Drive @ 38+60 RT MONTPELIER
Construction Details ME66-N 6400(7)
Scale: 1"=5'

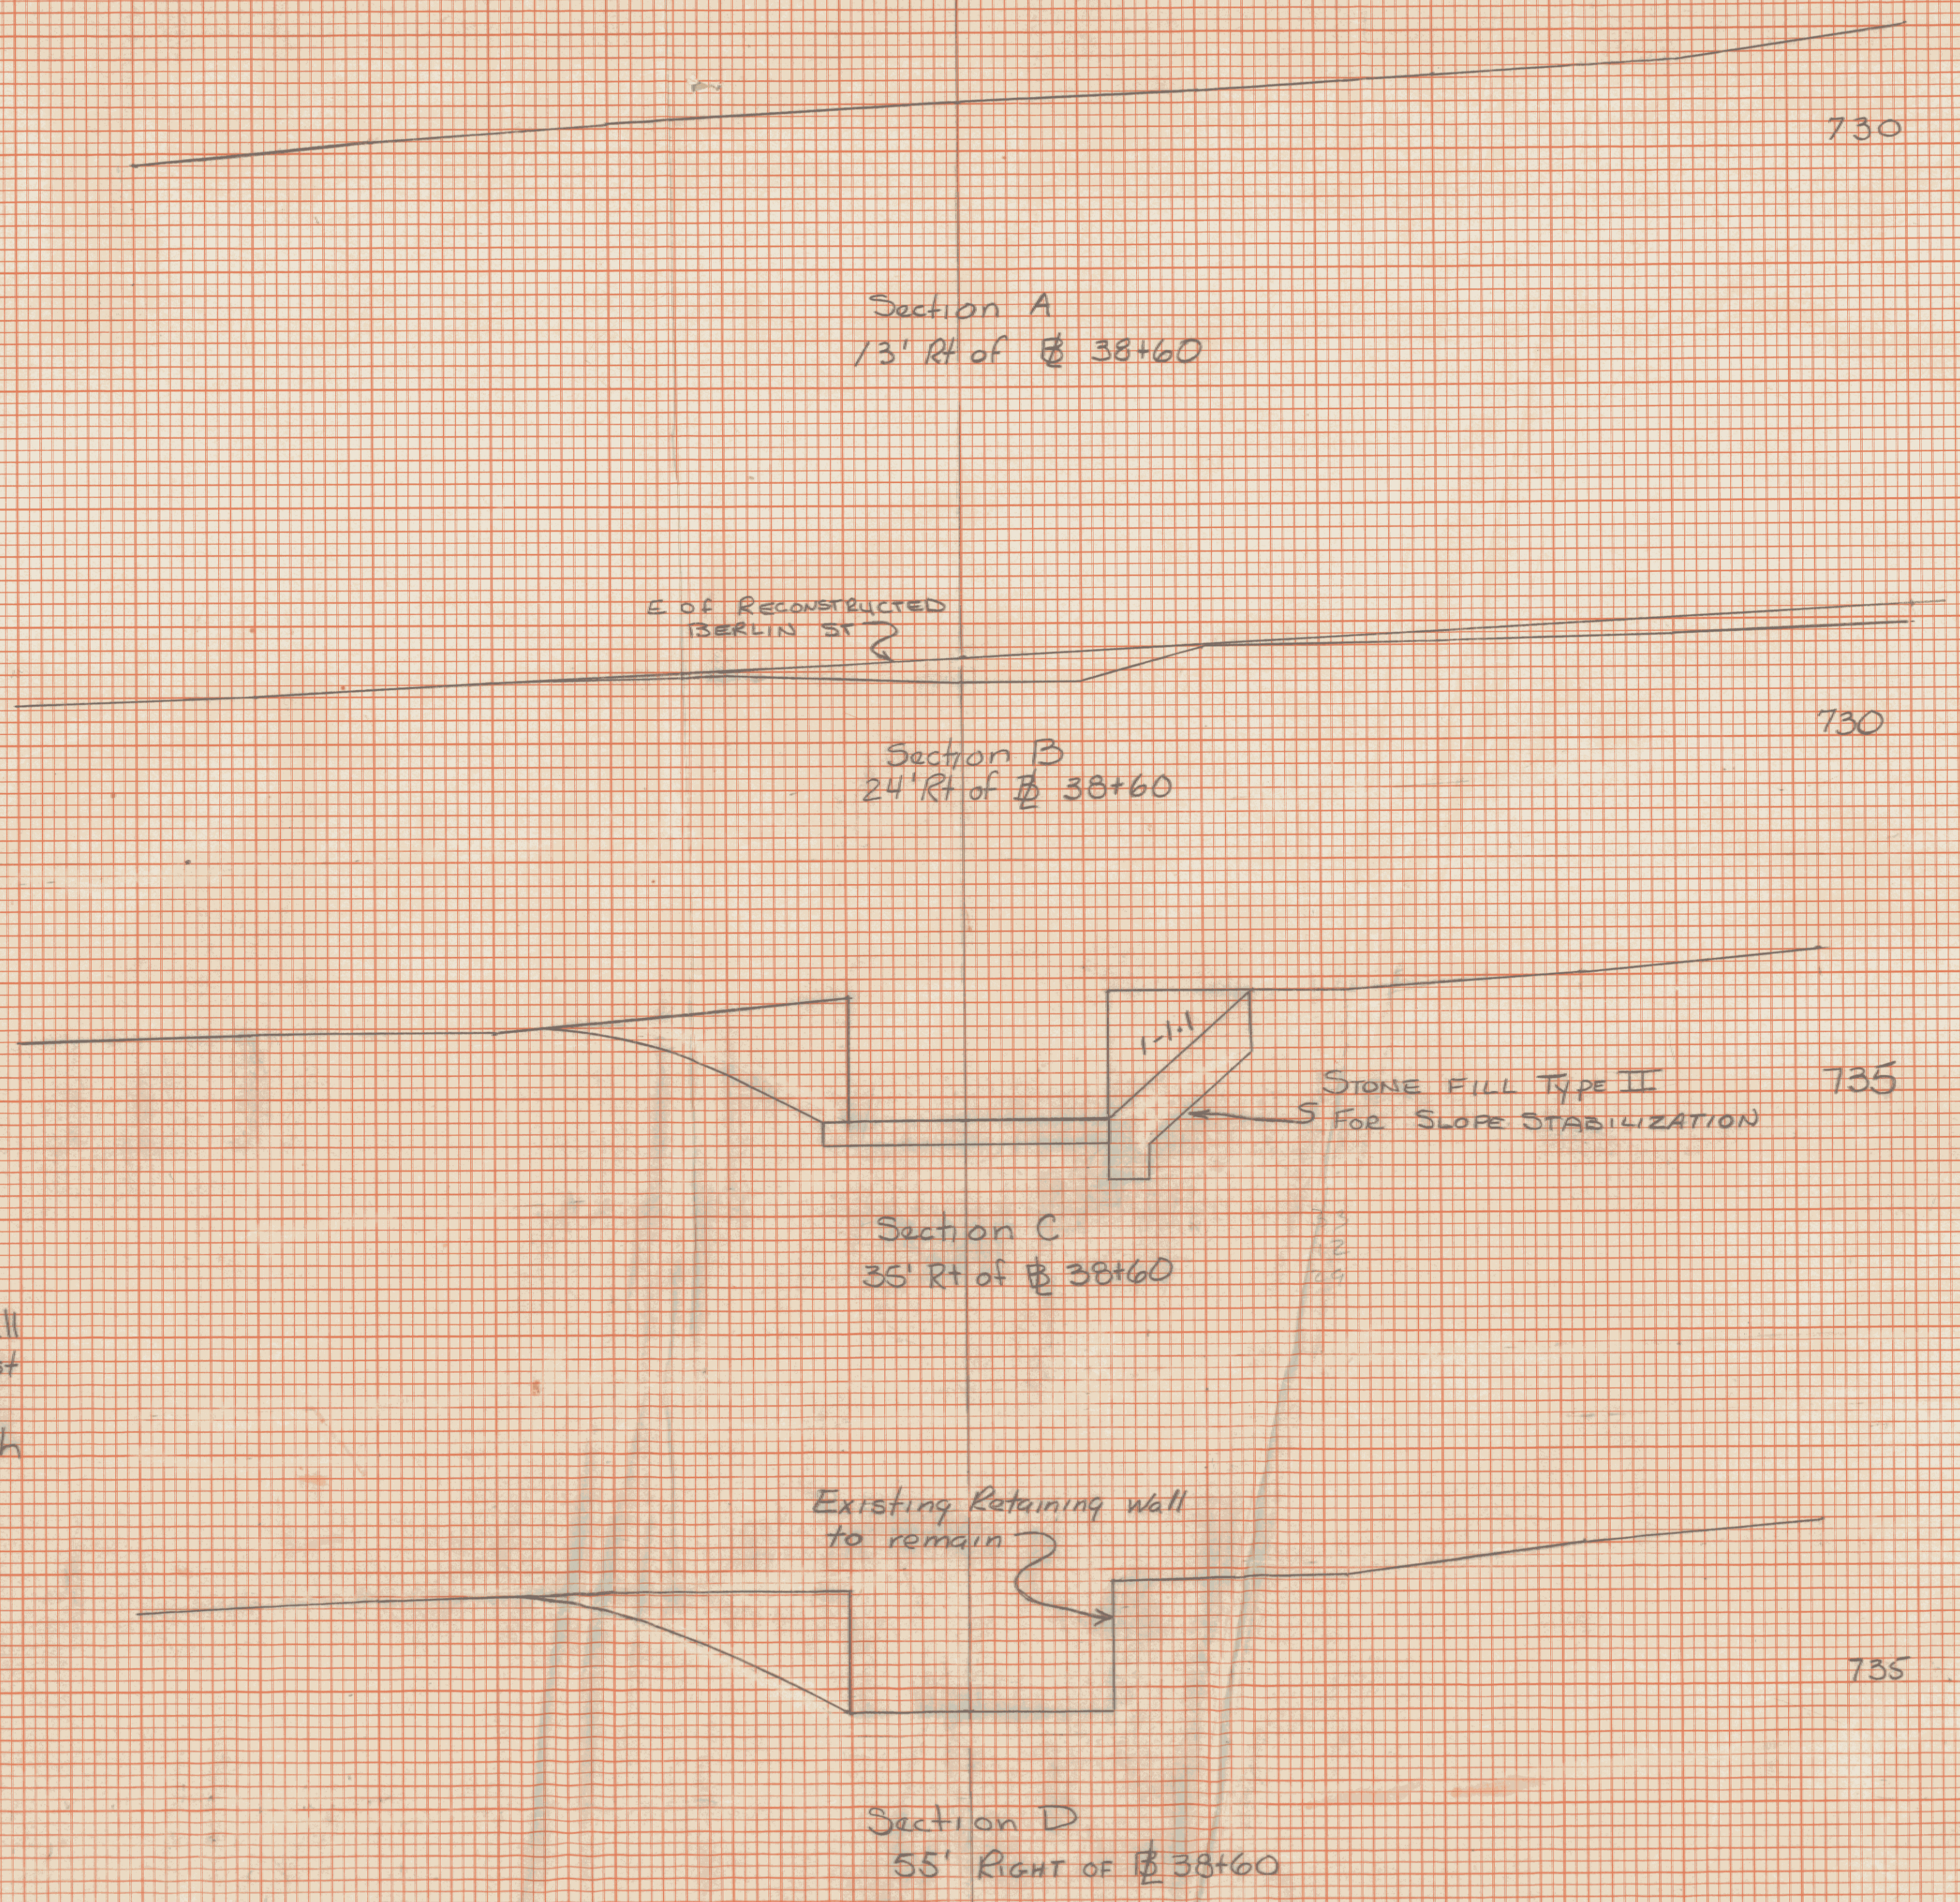
Remove Retaining Wall to Conc. Steps on Downstream Side

LIMIT OF RETAINING WALL REMOVAL

Remove entire retaining wall on upstream end - Cost of this removal to be paid under item 20421, Trench Excavation of Rock

Note: Any costs for repair of the retaining wall or concrete steps necessary due to the partial removal of the wall on the downstream end will be paid under item 501.25, Conc. Class B
